**CERTIFICATE OF APPROPRIATENESS**

**Property:** 1001 McKinney Street, lots 1, 2 & 6, tracts 12A & 13, block 137, SSBB Subdivision. The property includes a historic twenty-three story commercial building situated on a 20,204 square foot corner lot.

**Proposal:** Alteration – Remove the two lower, horizontal muntins in all 6-lite original windows on floors 3-16 on the east elevation to make a 4-lite configuration. Original aluminum frames and other muntins will be retained.

### NORTHEAST ELEVATION WINDOWS TO BE ALTERED

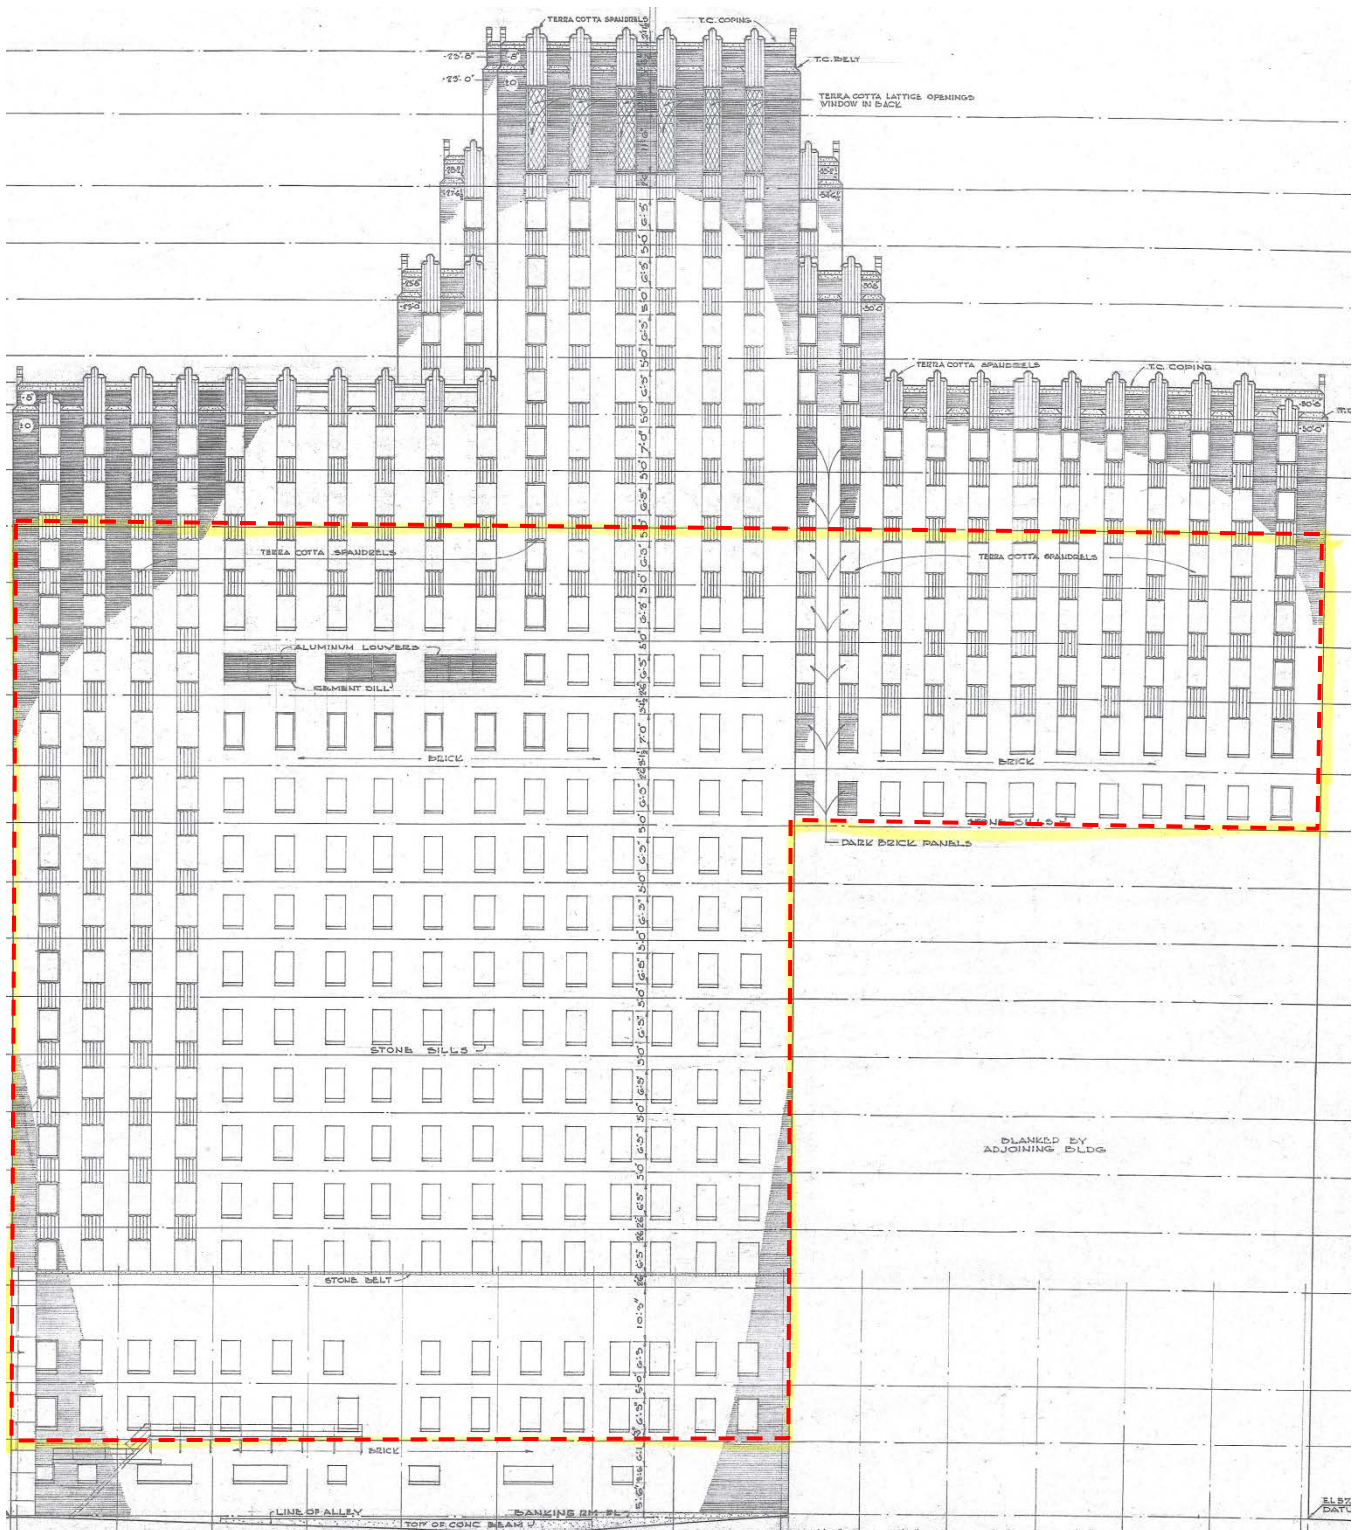
- (1) The proposed activity must retain and preserve the historical character of the property;  
*Window lite patterns are a distinctive aspect of the historic character of a structure. Altering the lite pattern on the majority of windows on the northeast elevation to match the other elevations creates a false history.*

- (4) The proposed activity must preserve the distinguishing qualities or character of the building, structure, object or site and its environment;  
*Window lite patterns are a distinctive aspect of the historic character of a structure. The 6-lite windows on the northeast elevation represent a dominant visual element on that elevation.*

- (5) The proposed activity must maintain or replicate distinctive stylistic exterior features or examples of skilled craftsmanship that characterize the building, structure, object or site;  
*Altering the lite pattern of windows on one elevation permanently changes a distinctive exterior feature.*

- (9) The proposed design for any exterior alterations or addition must not destroy significant historical, architectural or cultural material and must be compatible with the size, scale, material and character of the property and the area in which it is located;  
*The existing window muntins represent important historical material and should not be removed.*
